Docket Number:	15-AFC-01
Project Title:	Puente Power Project
TN #:	216914
Document Title:	EDC, Sierra Club and CBD Joint Comments RE Applicant's Bio Res Survey Methodologies
Description:	Comments from Environmental Defense Center, Sierra Club Los Padres Chapter, Ventura County Environmental Coalition and the Center for Biological Diversity
Filer:	Alicia Roessler
Organization:	Environmental Defense Center
Submitter Role:	Intervenor
Submission Date:	4/7/2017 4:39:50 PM
Docketed Date:	4/7/2017

Subject: Comments on Proposed Draft Biological Resources Survey Methodology for Puente Power Project, Oxnard, Ventura County, California.

The following comments are based on my review of AECOM's *Draft Biological Resources Survey Methodology* (Methodology), dated 27 March 2017, for conducting field surveys for special-status plants and wildlife at the proposed Puente Power Project.

Exhibit No. 4036

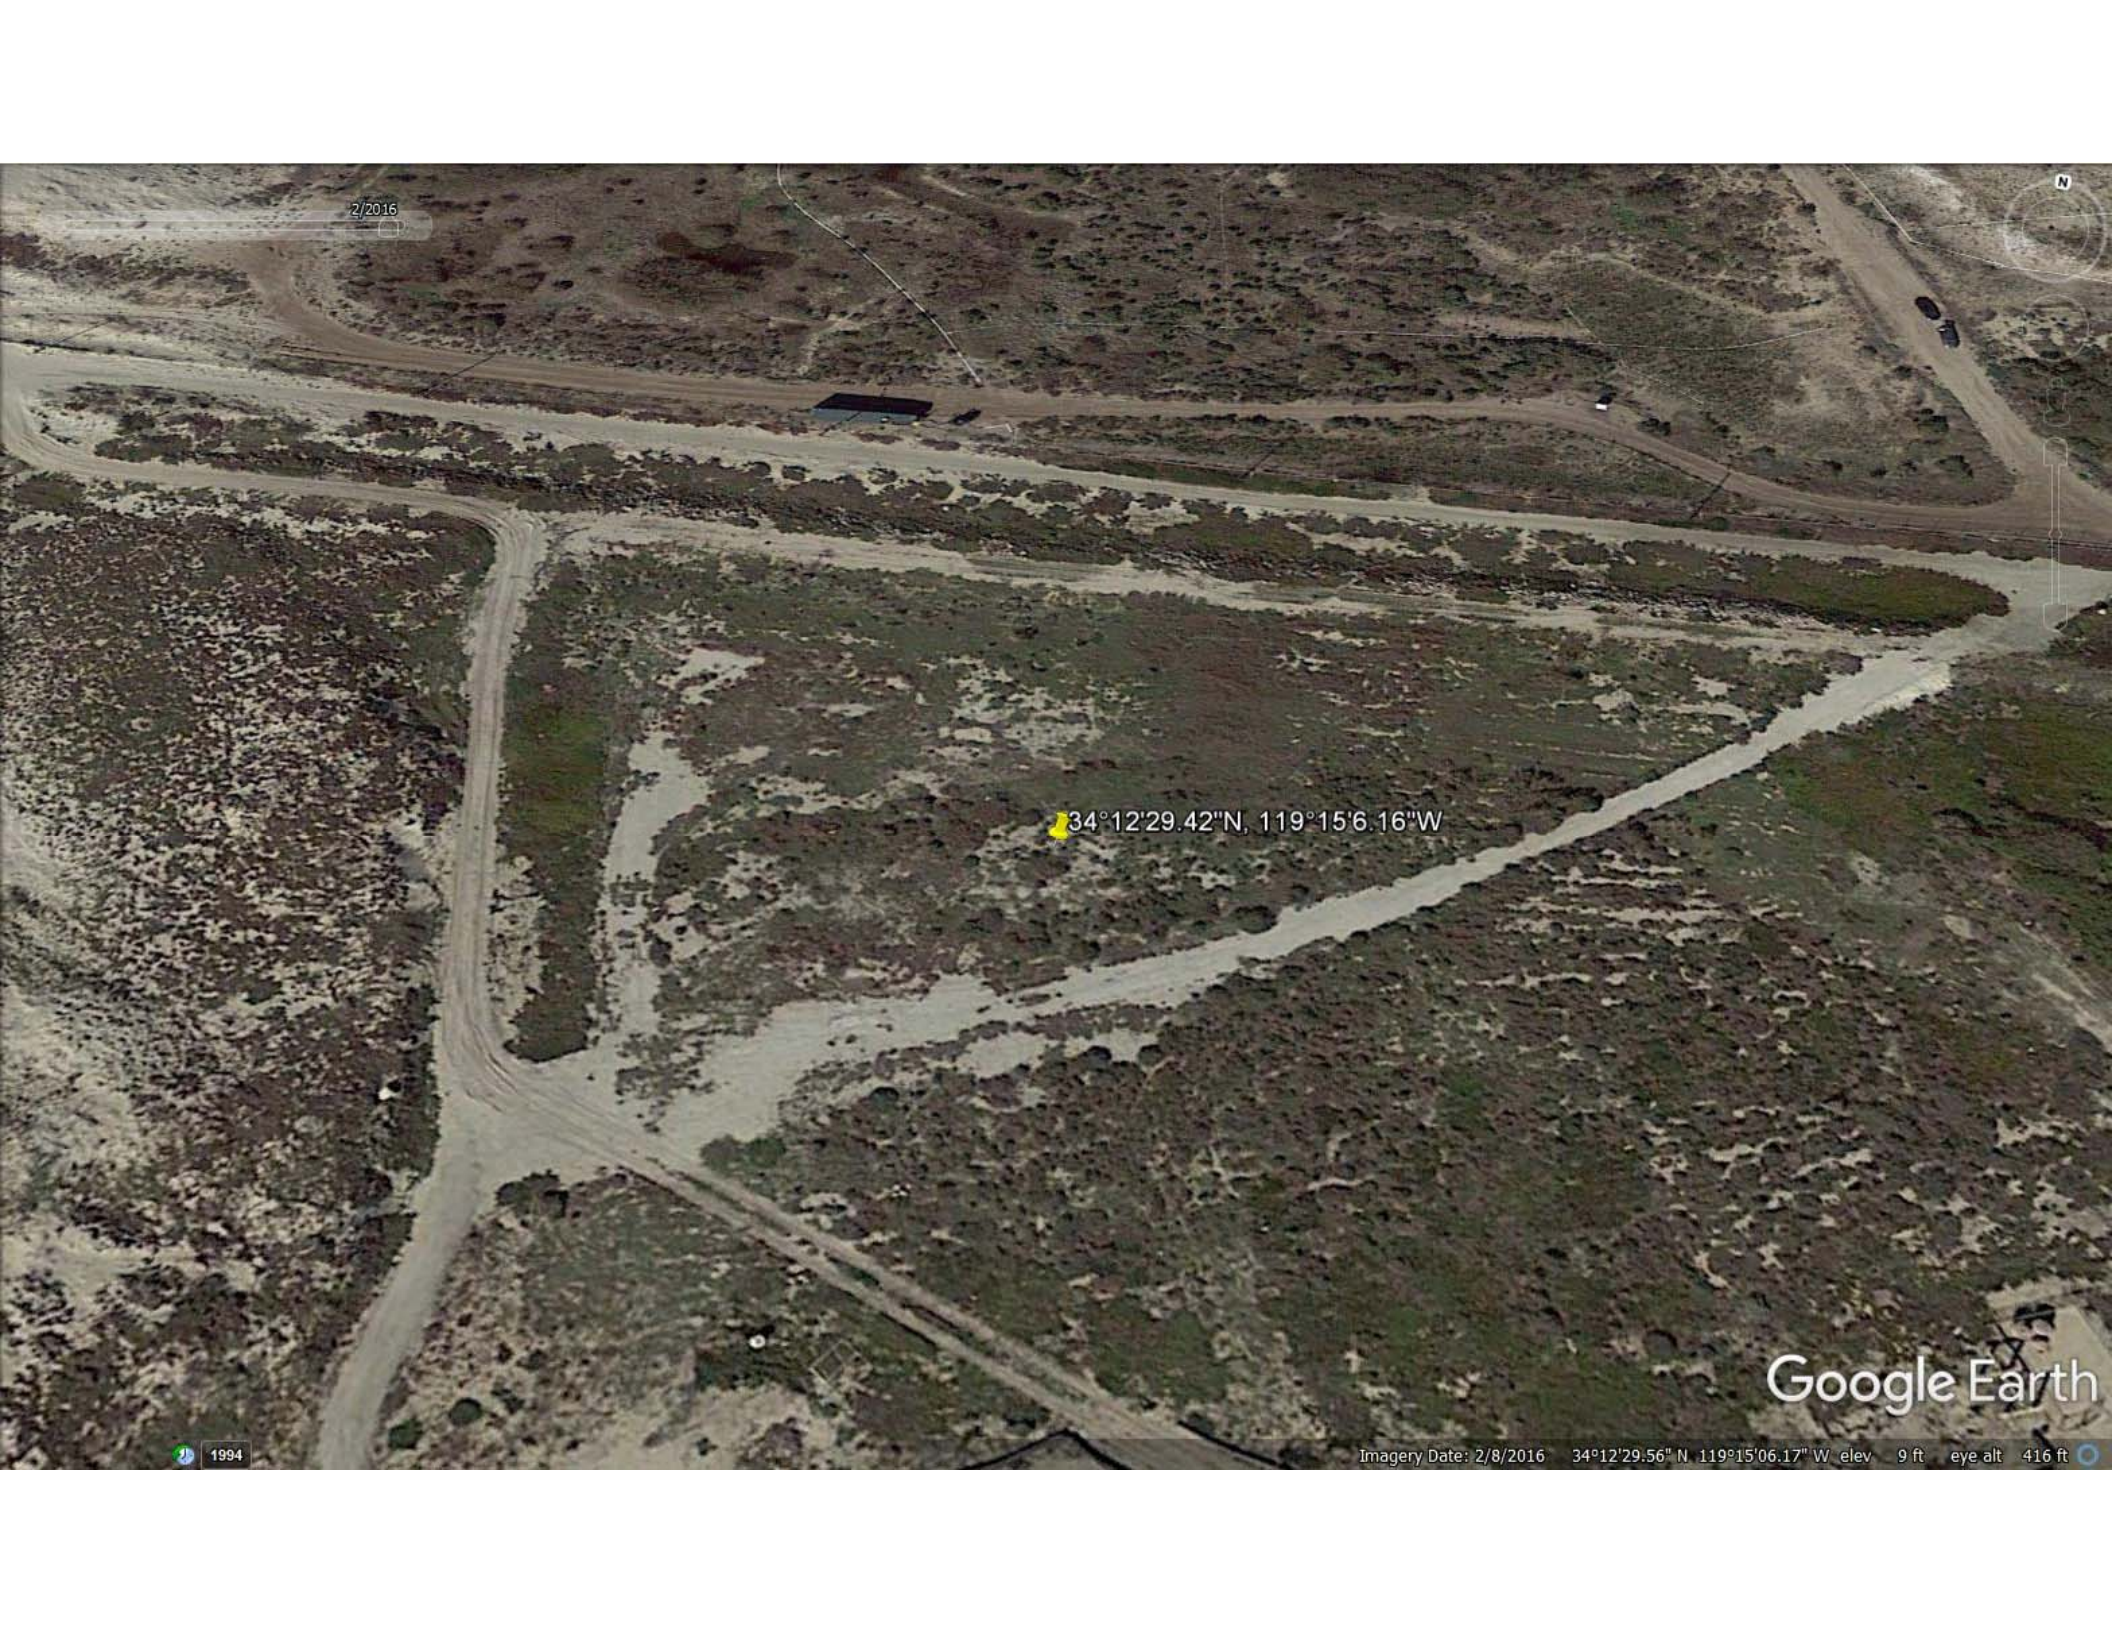
Intervenor objects to many of the statements and characterizations in the Survey Plan regarding the Project site’s habitat and conclusions regarding the presence of rare and sensitive species. Expert biologist Lawrence Hunt, who has been studying and conducting field studies for rare and sensitive species in the vicinity of the Project site since 1985, observed and provided testimony that the Project site is “physically surrounded by ESHA with no intervening barriers to dispersal” which gives rise to “a constant potential for special status habitat and wildlife to occupy the site.”¹ The site’s integration with the surrounding dune ecosystem is evident when observing the Project site boundaries near the surrounding sand dune ecosystem viewed from the Google Earth image of the Project site shown in Exhibit 4036, and also attached to these comments.
